ND-2012-0039  
July 19, 2012

Subject: **PSEG Early Site Permit Application**  
**Docket No. 52-043**  
**Response to Request for Additional Information, RAI No. 43, Vibratory Ground Motion**

**RESPONSE to RAI No. 43**

**QUESTION No.  
02.05.02-5**

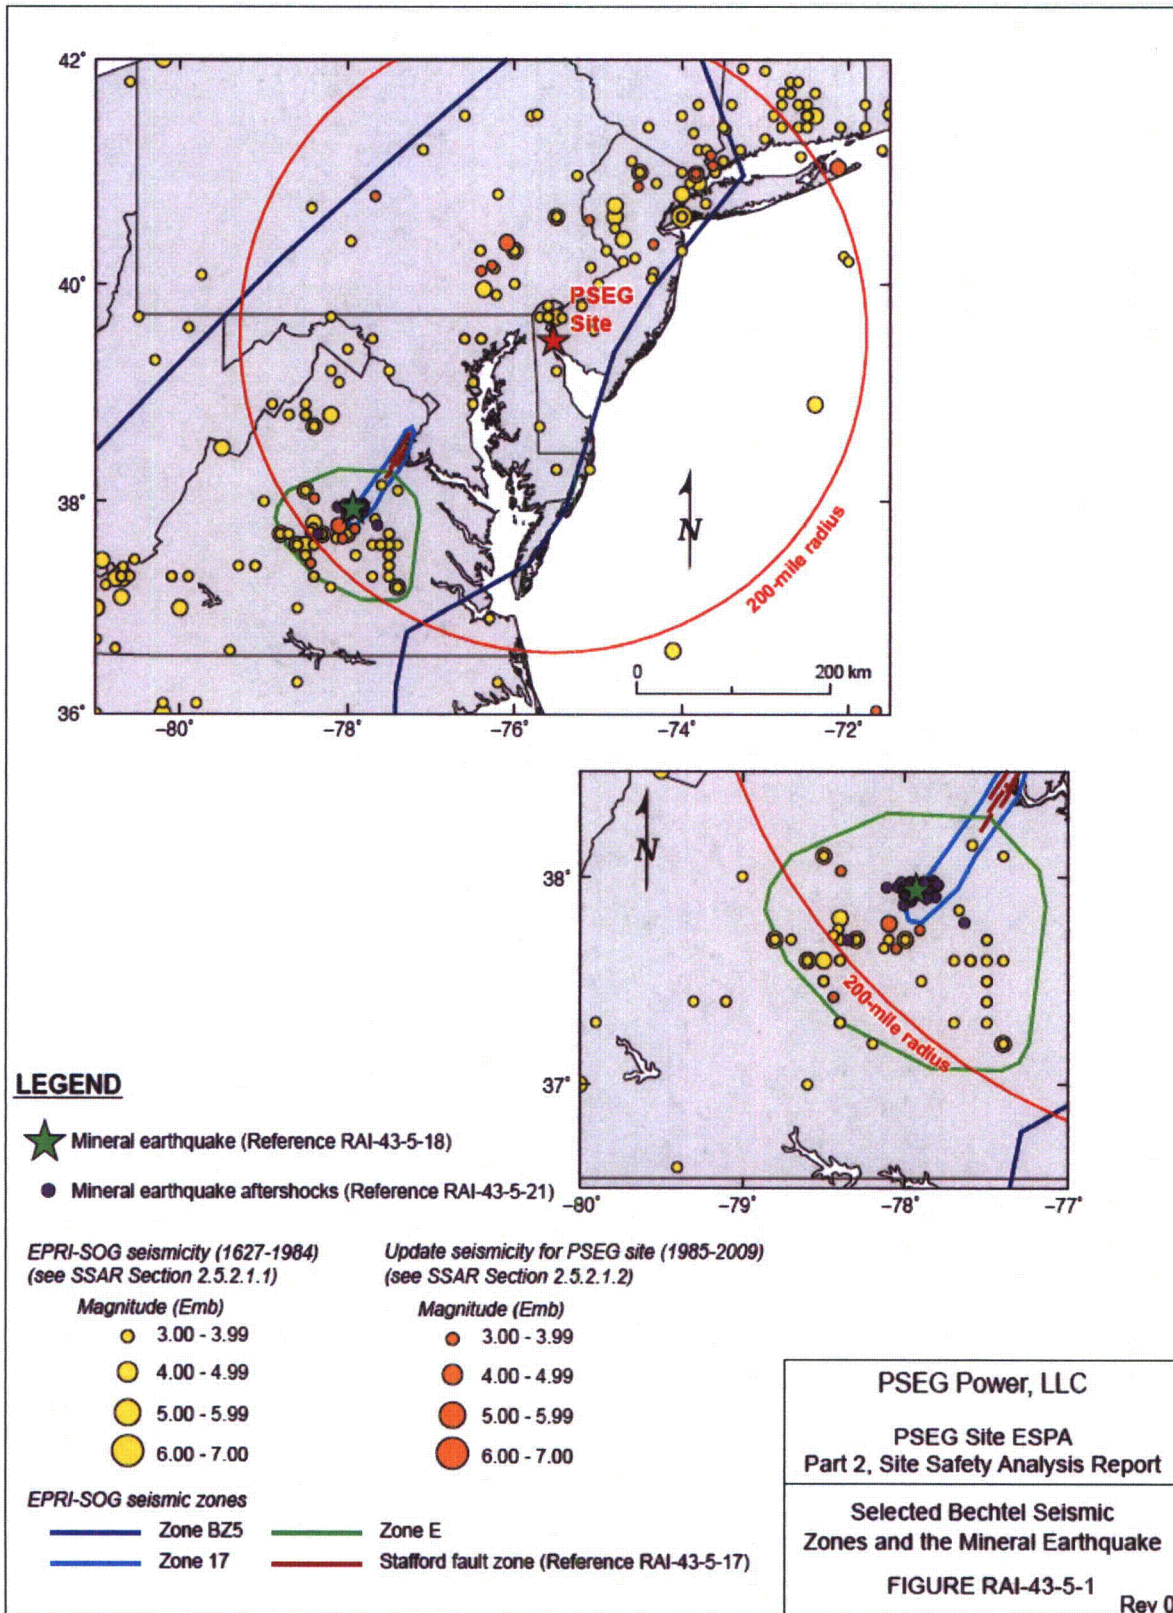
The Mineral earthquake occurred within two seismic sources identified by the Bechtel team: Zone E and Zone BZ5 (Table RAI-43-5-3; Figure RAI-43-5-1). The NEIC PDE-W location for the Mineral earthquake (Reference RAI-43-5-18) is less than 1 km (0.6 mi) outside the boundary of Zone 17. To account for potential moderate uncertainty in the location of the earthquake, Zone 17 is also considered to encompass the Mineral earthquake.

The lower-bound Mmax value for Zone 17 is mb 5.4 (Table RAI-43-5-3), so the Mmax distribution needs to be updated to account for the Mineral earthquake (mb 5.9). The Bechtel methodology for determining the Mmax distribution is outlined in the EPRI-SOG documentation (Reference RAI-43-5-10, Vol. 9, p. 6-20 to 6-23). The methodology, as relevant to Zone 17 and the Mineral earthquake, can be summarized as follows:

Applied to Zone 17 and the Mineral earthquake, this methodology gives an updated Mmax distribution of: 5.9 (0.1), 6.2 (0.4), 6.5 (0.4), and 6.6 (0.1) (Table RAI-43-5-1).

The occurrence of the Mineral earthquake requires updating the Pa evaluation for Zone 17 because the largest observed earthquake in the zone prior to the Mineral earthquake was Emb 3.38. Therefore, the weight that the zone is associated with moderate to large seismicity needs to be increased from the original value of 0.1. Because the Bechtel methodology does not provide enough information to determine how the occurrence of the Mineral earthquake would impact the evaluation of association with seismicity, we conservatively increased the association with moderate to large earthquakes to 1.0 and decreased the association with small earthquakes and no seismicity to 0. Applying these changes results in an updated Pa value of 0.60, including the additional 0.05 subjective probability originally defined by the Bechtel team (Table RAI-43-5-1).

Zone E was developed by the Bechtel team to represent the CVSZ. The lower-bound Mmax value for Zone E is mb 5.4 (Table RAI-43-5-1), so the Mmax distribution needs to be updated to account for the Mineral earthquake. The Bechtel methodology for determining the Mmax distribution for Zone E is the same as described above for Zone 17. Applying this methodology to Zone E gives an updated Mmax distribution of: 5.9 (0.1), 6.2 (0.4), 6.5 (0.4), and 6.6 (0.1) (Table RAI-43-5-1).

To account for the Mineral earthquake, the weight that the Zone E is associated with (moderate to large seismicity) needs to be increased from the original value of 0.35. Because the Bechtel methodology does not provide enough information to determine how the occurrence of the Mineral earthquake would impact the evaluation of association with seismicity, we conservatively increased the association with moderate to large earthquakes to 1.0 and decreased the association with small earthquakes and no seismicity to 0. Applying these changes results in an updated Pa value of 0.51 (Table RAI-43-5-1).

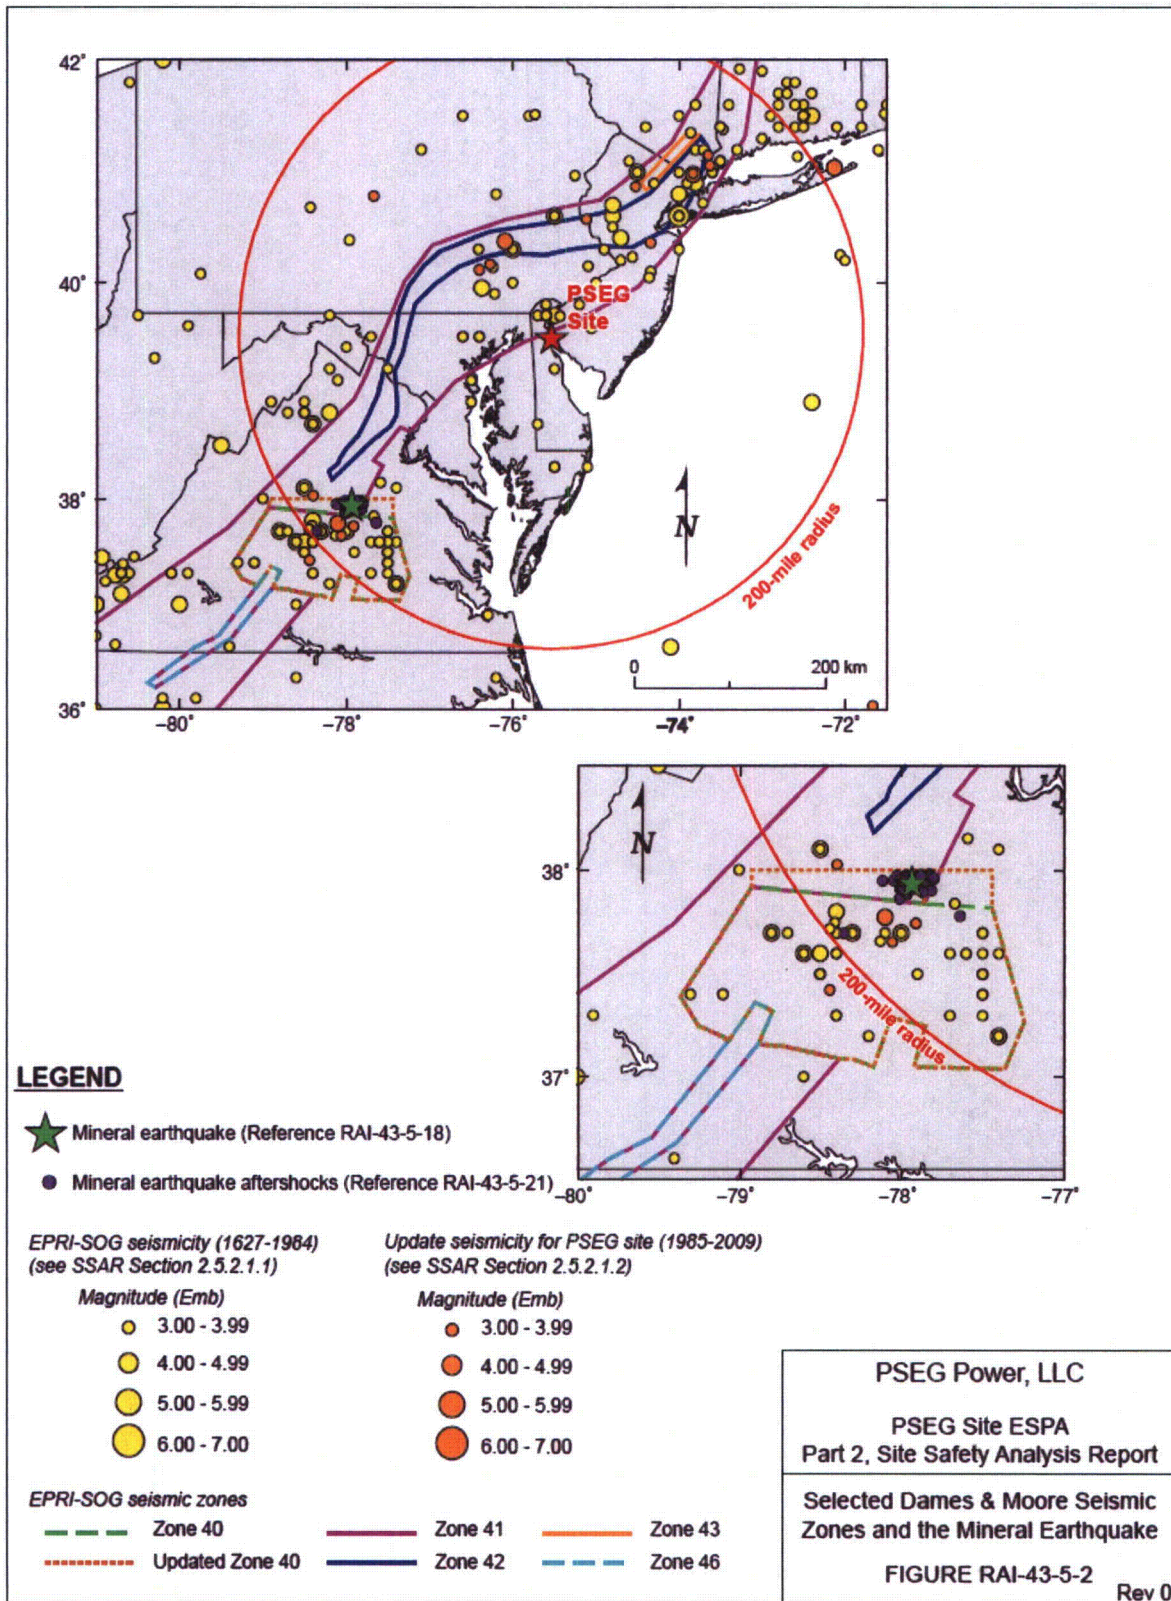
The Mineral earthquake occurred within one seismic source identified by the Dames & Moore team, Zone 41, which is mutually exclusive with Zones 42, 43, and 46 (Table RAI-43-5-3; Figure RAI-43-5-2). However, Zone 41 was defined by Dames & Moore as a default zone (e.g., a background zone) for zones 42, 43, and 46. Zones 42, 43, and 46 represent the Newark Basin, the Ramapo fault, and the Dan River fault, respectively, tectonic features not related to the CVSZ. In contrast, the Mineral earthquake is considered by most researchers to be related to the CVSZ (References RAI-43-5-3, RAI-43-5-4, RAI-43-5-8, RAI-43-5-14, RAI-43-5-15, RAI-43-5-16, RAI-43-5-22, RAI-43-5-23). The Dames & Moore team did define a CVSZ (Zone 40), which they clearly intended to represent the region of high seismicity within central Virginia (Reference RAI-43-5-10, Vol. 6, p. B-31). Therefore, Zone 40 should be updated to account for the Mineral earthquake, and no changes should be made to Zones 41, 42, 43, or 46.

Because the Mineral earthquake occurs outside of Zone 40 and closer to the PSEG Site than the current boundary of Zone 40, the geometry of the zone should be updated to appropriately represent the location of the Mineral earthquake. Figure RAI-43-5-2 shows the original boundary of Zone 40, the location of the Mineral earthquake, and the location of aftershocks located by the St. Louis University Earthquake Center (Reference RAI-43-5-21). The geometry of Zone 40 is updated by extending the northern boundary of the zone northward to encompass the Mineral earthquake and the identified aftershocks. This is a reasonable and adequate modification of the Dames & Moore team's representation of the CVSZ because: (1) it mostly maintains the original geometry of the zone by only extending the northern boundary; and (2) it encompasses the seismicity related to the Mineral earthquake that is thought by most researchers to be associated with the CVSZ (References RAI-43-5-3, RAI-43-5-4, RAI-43-5-8, RAI-43-5-14, RAI-43-5-15, RAI-43-5-16, RAI-43-5-22, RAI-43-5-23).

It should be noted that extending the northern boundary of Zone 40 further north creates an overlap between Zone 40 and Zones 41 and 53 (see SSAR Figure 2.5.2-6) and thus a double counting of seismicity from this region of overlap. The overlap between the zones is relatively small, so Zones 41 and 53 are not modified to remove the overlap.

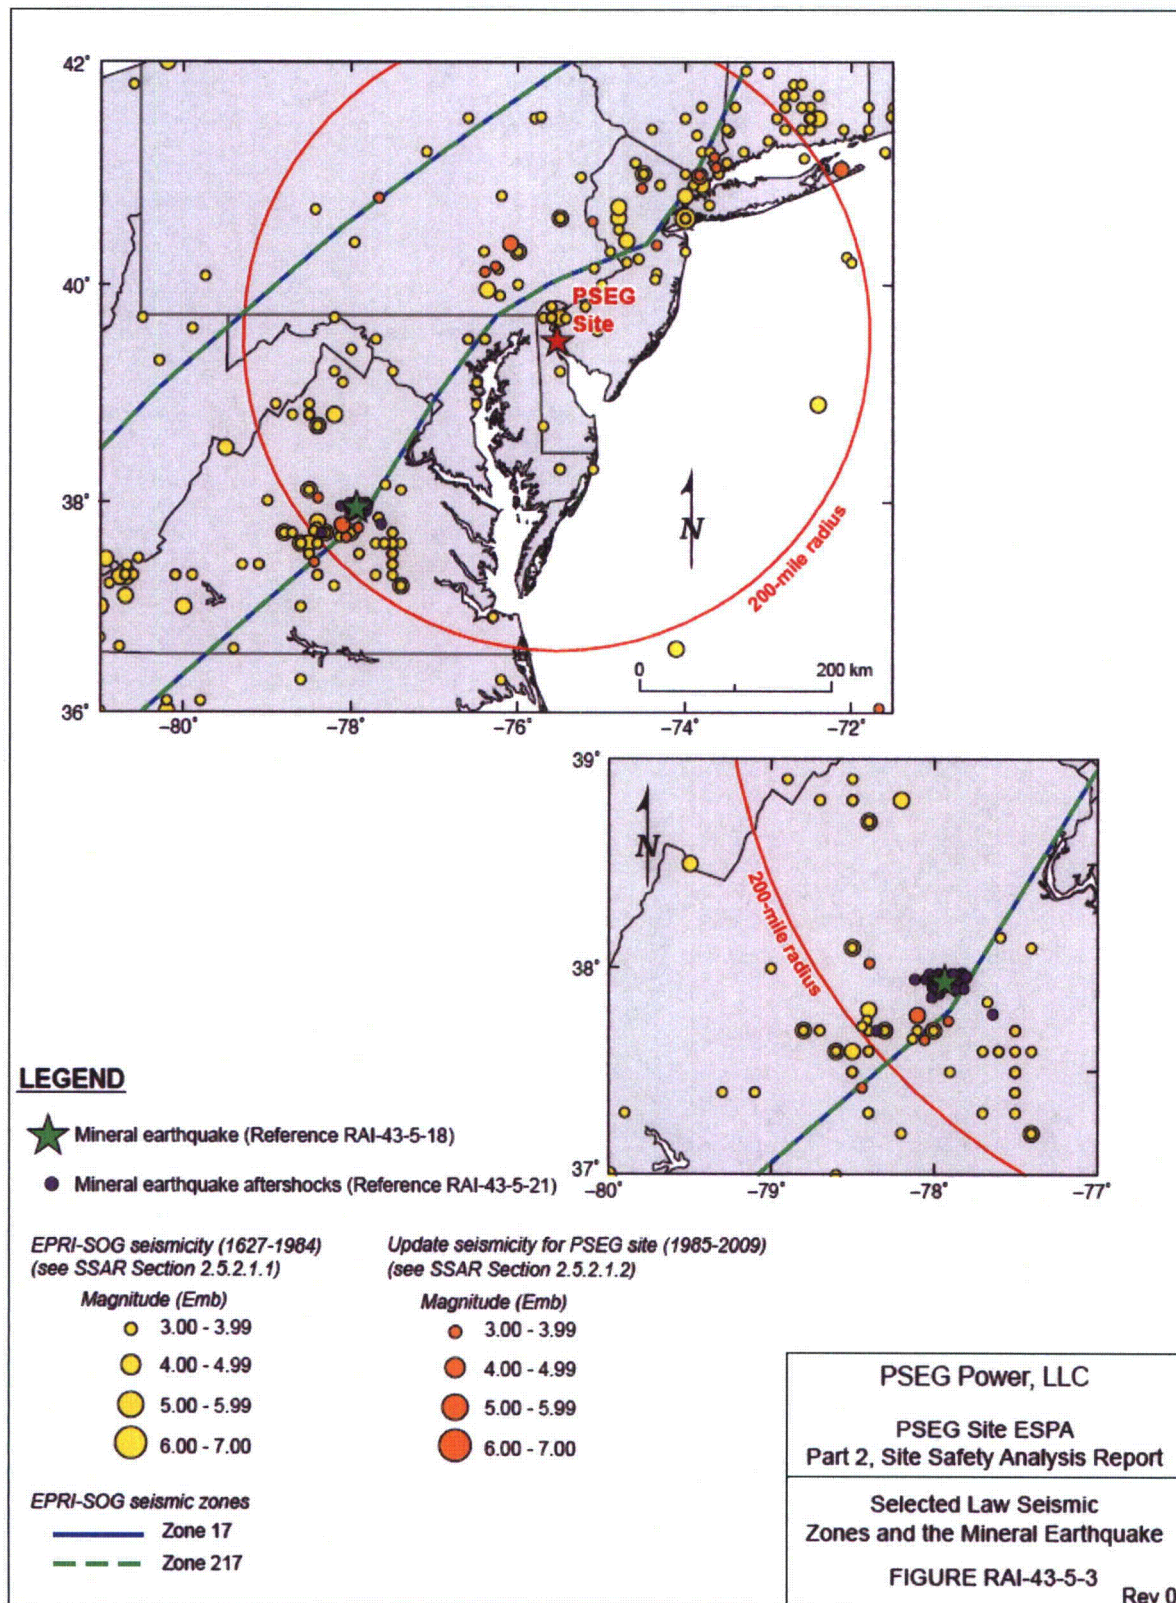
The Mineral earthquake occurred within two zones defined by the Law team: Zone 17 and Zone 217 (Table RAI-43-5-3; Figure RAI-43-5-3). Zone 17 is an expansive zone that extends along the eastern US from Alabama to Vermont, and Zone 217 is a background zone with the same geometry as Zone 17 (Figure RAI-43-5-3; SSAR Figure 2.5.2-7). The Law team did not define a seismic zone for the CVSZ. Based on the documentation of the Law team's methodology, they followed a strict tectonic feature approach to defining seismic zones, and they tended to not define seismic zones that did not have a potentially related tectonic feature (Reference RAI-43-5-10, Vol. 7, p. 5-2). The only exceptions the Law team made to this methodology are their characterizations of the seismic zones for Charleston and Ottawa (Reference RAI-43-5-10, Vol. 7, p. 5-7).

The occurrence of the Mineral earthquake may require updating the Pa evaluation for Zone 17. The Law team assigned a 0.6 weight that moderate to large seismicity (i.e.,  $m_b \geq 5.0$ ) is associated with the zone. Prior to the Mineral earthquake, the largest earthquake within the zone that the Law team used in making this evaluation was the 1897 Emb 5.7 Giles County earthquake. It is not possible to determine how the Law team would have modified their 0.6 weight given the occurrence of the slightly larger ( $m_b$  5.9) Mineral earthquake. Due to this uncertainty, the weight that Zone 17 is associated with (moderate to large seismicity) is increased to 1.0, and the weights that the zone is either not associated with seismicity or is associated with small earthquakes only are set to 0. These changes are conservative, especially in light of the fact that the Law team already knew of an Emb 5.7 earthquake within the zone.

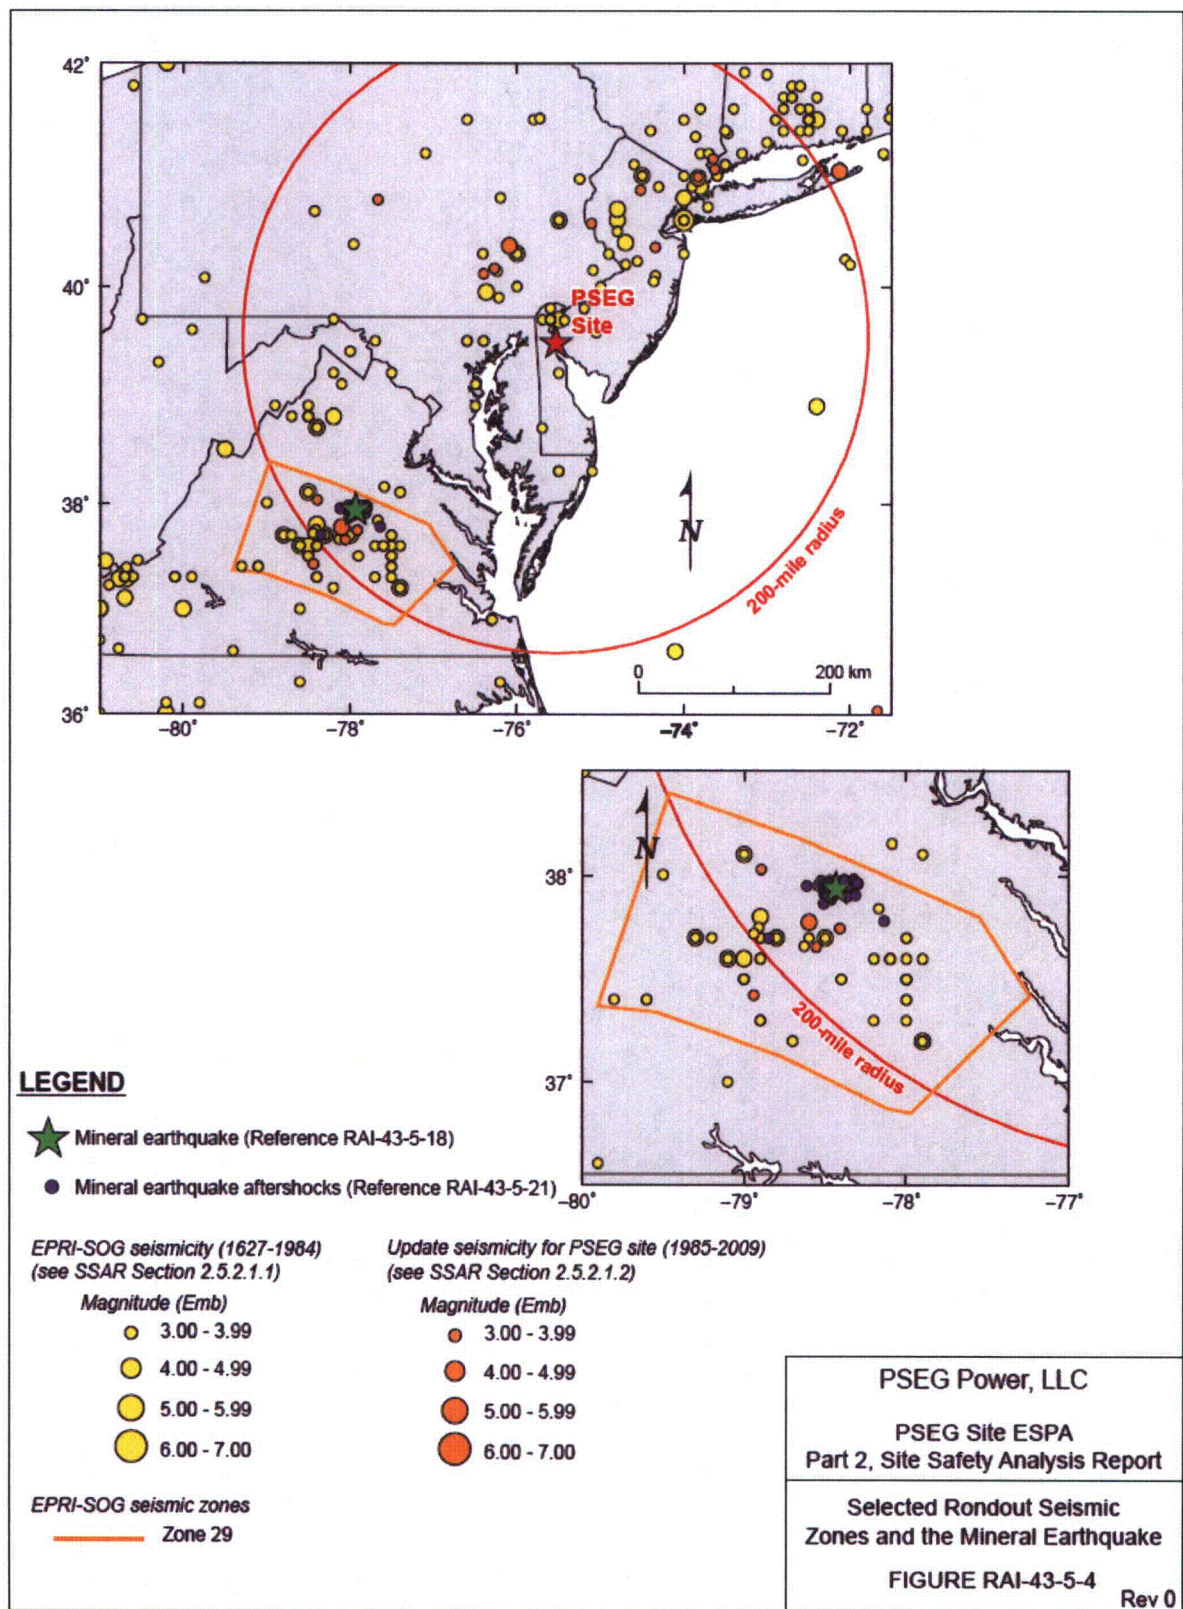
The Mineral earthquake occurred within one zone defined by the Rondout team: Zone 29 (Table RAI-43-5-3; Figure RAI-43-5-4). Zone 29 has a lower-bound Mmax value of  $m_b$  6.6 and a Pa value of 1.0 (Table RAI-43-5-3). Therefore, there are no updates to Zone 29 required due to the occurrence of the Mineral earthquake.
